Appeal In The Matter Of Department Permits L-24572-24-C-N, L-24572-TF-D-N, L-24572-IW-E-N, L-24572-24-F-N and L 24572-TF-G-N // Approval for Oakfield Wind Project Expansion

Licensee's October 21, 2011 Response to IFW Comments

Subject: Response to Maine Department of Inland Fisheries and Wildlife September 28, 2011, Comments Regarding the Amendment Applications for the Oakfield Wind Project, DEP # L-24572-24-E-A

Figure 1. Timing of bat fatality at Maine wind projects

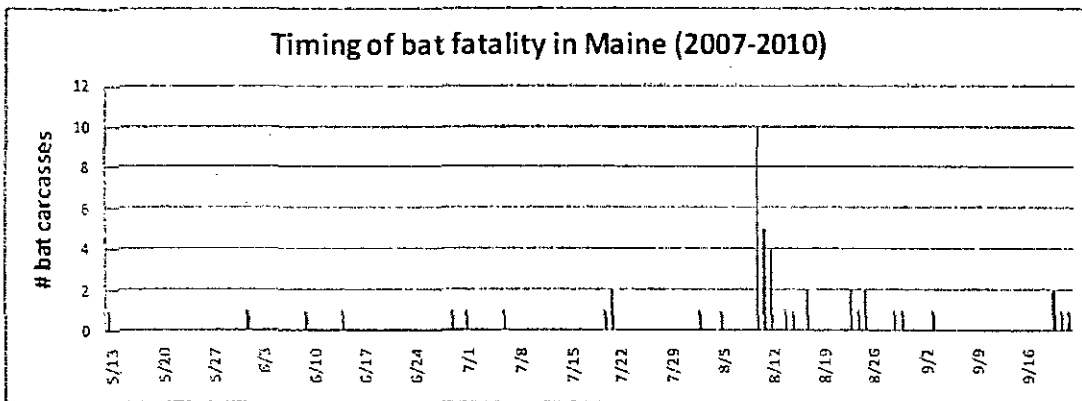
Recent studies (Arnett et al. 2009 & 2010, Baerwald et al. 2008) at operating wind facilities have indicated that increasing the cut-in speed (the wind speed at which the turbine is allowed to begin rotating) for operating turbines to 5.0 meters per second has significantly decreased turbine caused fatalities for bats. Therefore, in order to minimize risk of mortality to bats MDIFW recommends that operational control measures be established for the Evergreen Wind Power Project in Oakfield/T4 R3 WELS. These measures should be employed from April 20th through October 15th, such that the applicant set the turbine cut-in speed to 5.0 m/s starting at one-half hour before sunset to one-half hour after sunrise. During this time frame when the wind speed is less than the 5.0 m/s threshold, turbine blades are not allowed to rotate thus reducing risk of fatality for bats. If at any point during this time period the wind speed increases to > 5.0 m/s the turbine blades are free to rotate. These curtailment measures are intended to be in place from day one of operation for the life of the project. They are not intended to be reactionary mitigation triggered by some threshold based on pre or post-construction studies. MDIFW would consider not requiring post-construction bat mortality studies with the curtailment recommendations in

A review of existing bat mortality data is important to evaluate MDIFW's recommendation for curtailment. To date, the earliest bat fatality documented at three operational projects in Maine (Mars Hill, Stetson I, and Stetson II) with publicly available post-construction monitoring results occurred at the Mars Hill Wind Project on May 13, 2007. This has been the only bat fatality documented in Maine prior to June, with the greatest mortality occurring in August (see Figure 1 below and Attachment A, Table 1). As such, we believe that implementing operational control measures prior to June is unwarranted given the costs to the project and the very limited potential benefit in reducing bat mortality. Furthermore, the studies referenced in MDIFW's comment only implemented operational control measures during the period known to encompass the peak in bat fatalities at other operational wind projects (July through September, usually 80% of bats found at a project have been killed during this time frame). The Arnett, *et al.*, 2009 and 2010 studies occurred from late July to early October, and the Baerwald, *et al.*, 2009 study occurred from mid-July to late September.

Operational control measures will be implemented as noted from June through September. This period is one month prior and one month subsequent to the peak period of bat fatalities (July through August) as observed at operational wind projects in Maine and the northeast. Operational control measures will occur during night hours when bats are active (roughly 0.5 hour after sunset until sunrise) and when wind speeds as measured at turbine nacelles are less than 5 m/s. Operational controls will also be limited to times when temperatures are above 50 degrees Fahrenheit during June and July, and limited to times when temperatures are above 32 degrees during August through October. The reason for implementing operational control measures on nights when temperatures are above 50 degrees only during June and July is because foraging bats are not expected to be active on colder nights during the summer (i.e., when insect prey abundance is lower). During August through October, when bats are likely migrating, colder temperatures may not limit activity, so control measures will be implemented on all nights with above freezing temperatures.

Figure 2. Snapshot of the existing road in SVP habitat for 19SM-N and 34MA-N that is to be revegetated.

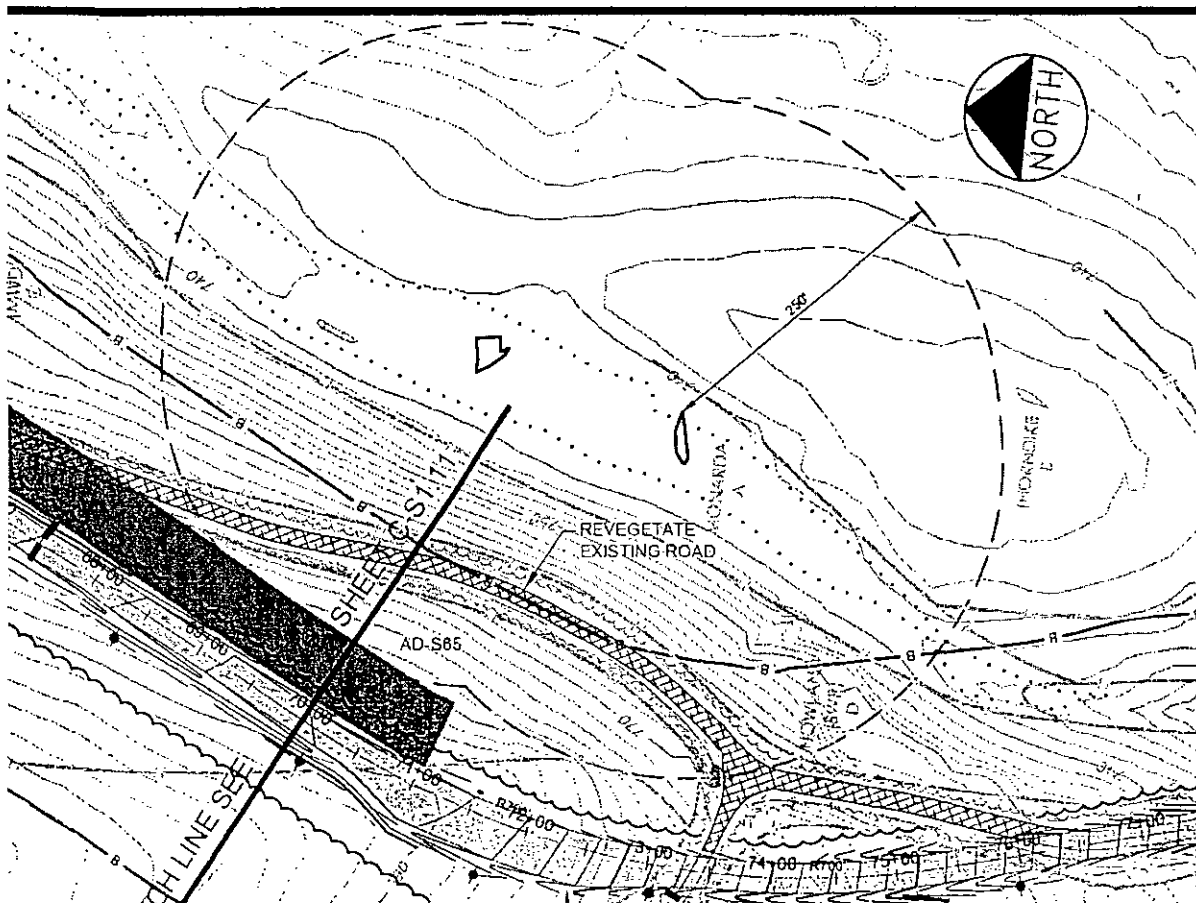
- 1) 30ED_N: clearing for turbine pad E06 just clips the edge of the upland zone (4% according to 8/23/11 email from Brook Barnes).
- 2) 19SM_N: proposed access road runs through the 250 foot upland zone (<25%; no % figures provided by Stantec; not addressed on Impact Maps accompanying permit application).
- 3) 34MA_N: proposed access road runs through the 250 foot upland zone (<25%; no % figures provided by Stantec; not addressed on Impact Maps accompanying permit application).

MDIFW states that the 3 remaining SVPs (19SM_N, 34MA_N, 30ED_N) "appear to be impacted" by the project. It is correct that SVP30ED-N will impact 4 percent of the SVP habitat. However, the road referenced in the comments regarding 19SM-N and 34MA-N is an existing road, not a proposed road. As part of the compensation for this project, the existing road will be abandoned and revegetated, restoring habitat within the SVP. Figure 2, below, shows a snapshot of the restoration area is from Exhibit 1, Sheet C-S1.12 of the civil design. The dark area is an undisturbed stormwater buffer.

Distance to Nearest Heron Rookery

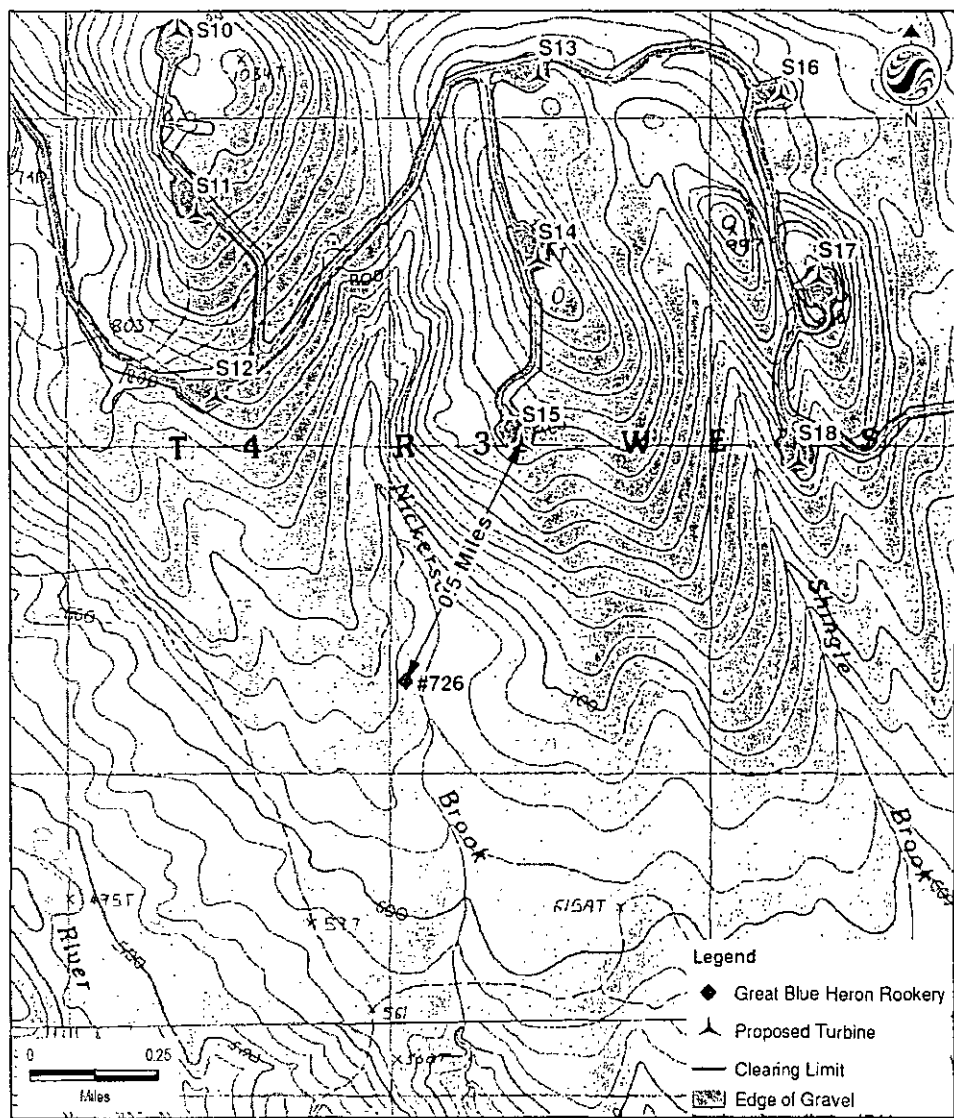
This colony has been active in recent years, but I do not believe this will be an issue being 0.6 miles from nearest proposed turbine as long as other construction (i.e., roads) are no closer than 1/4 mile. Within 0.25 mi, I would suggest avoiding construction activities during 1 Apr thru 15 Aug. Within 2.5 miles, protection of wetlands used for foraging may be critical, so suggest adopting practices that protect water quality, limit erosion, and protect upland vegetation within 75 ft of wetland edges.

The closest point of construction to the heron rookery (#726) is 0.48 mile (See Attachment B). This distance was based on the clearing limit around turbine S15, which is 0.48 mile northeast of the rookery. A map of its location is attached as Attachment B. No construction activity will occur within 0.25 mile of the rookery.
